Frederick County Planning Commission

October 13, 2021

Lake Linganore Boulevard

Preliminary Plan

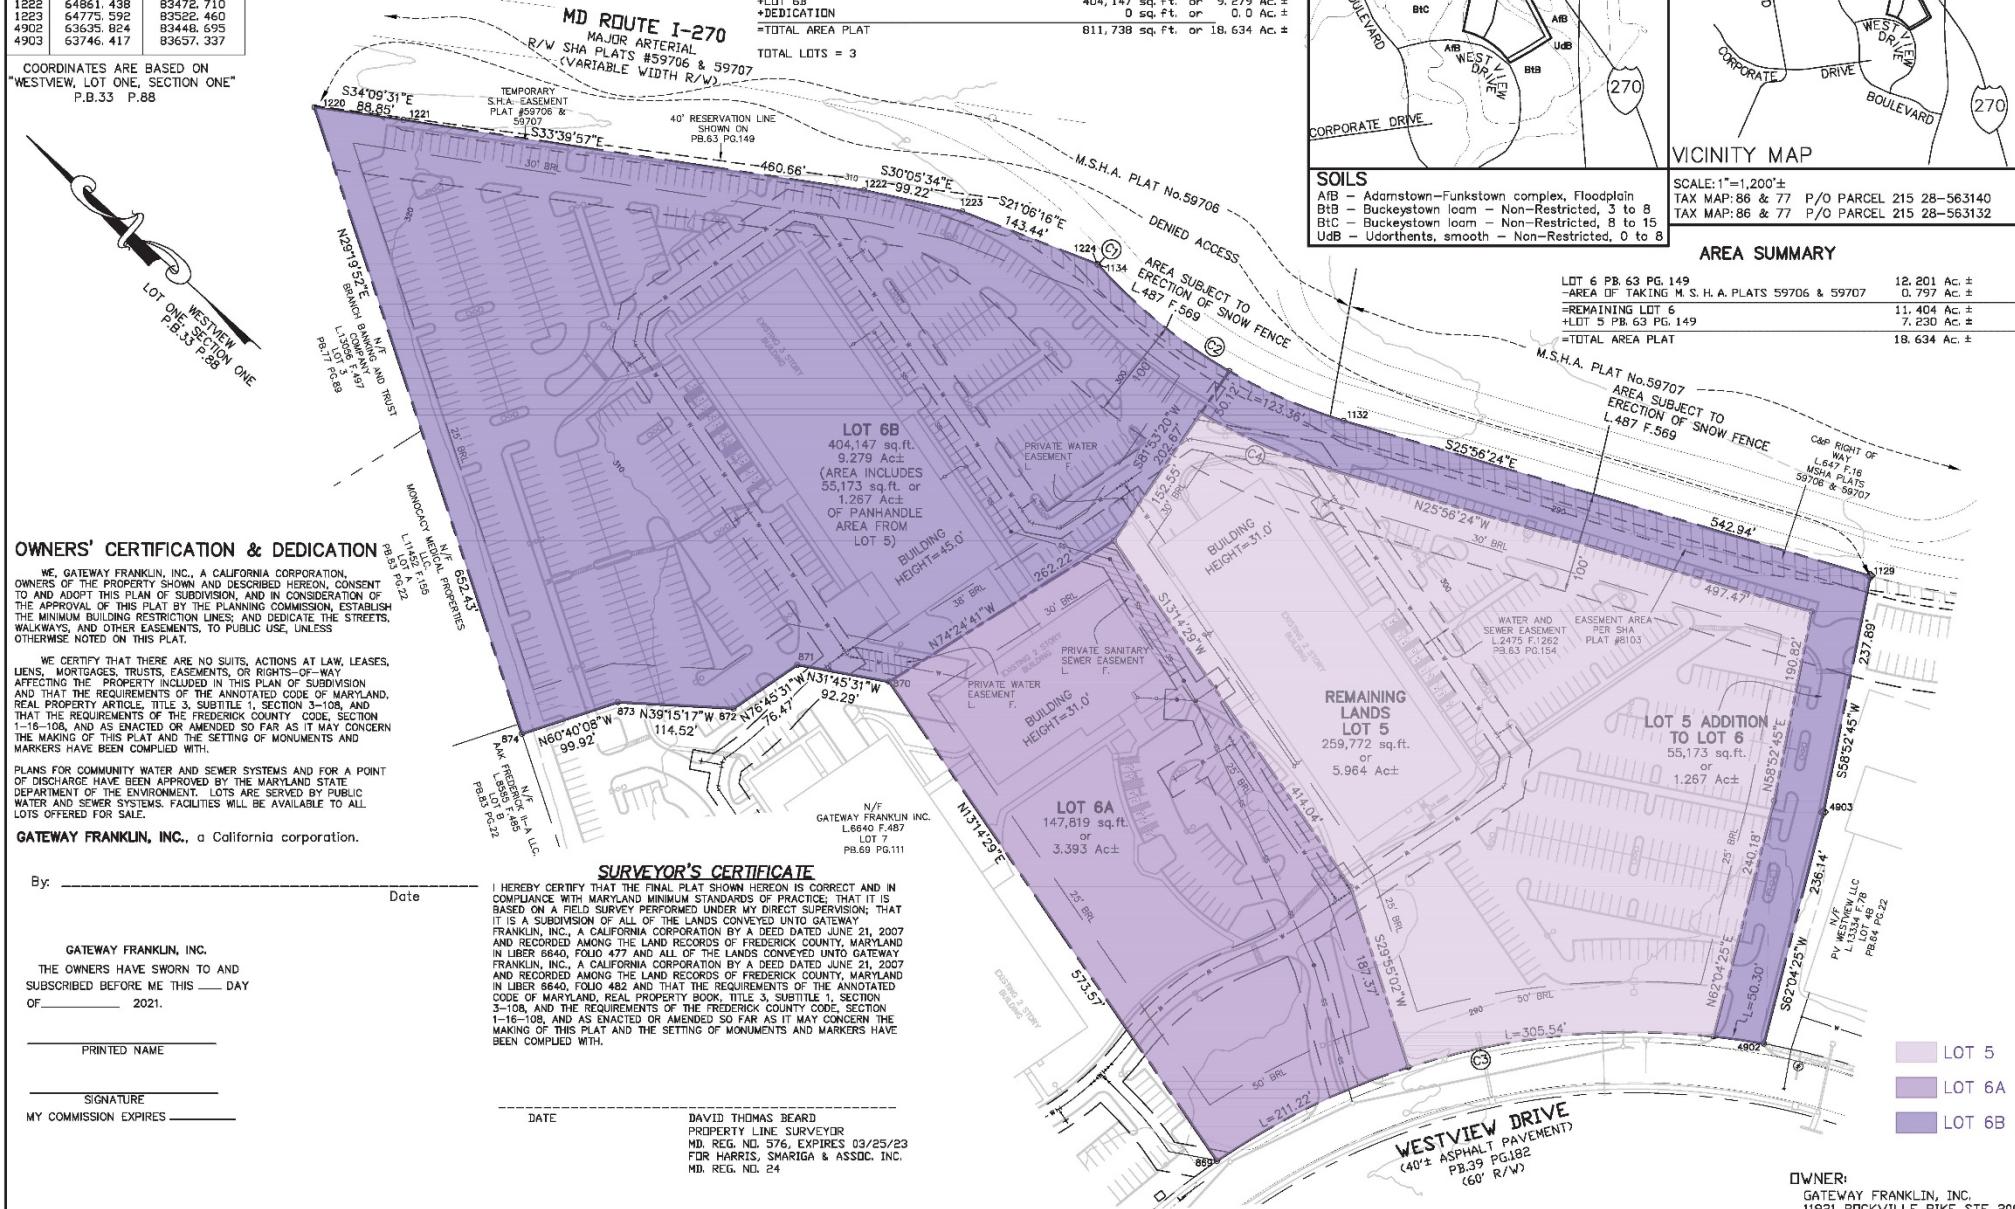
1. A panhandle modification under §1-16-219(c)(2) to accommodate this subdivision by providing usable fee-simple public road frontage for Lot 6B.

1. The Applicant shall comply with all Staff and agency comments through the completion of the plan.
2. Prior to plat recordation, private water and sewer easements must be recorded and the easements must be shown and referenced on the plat.
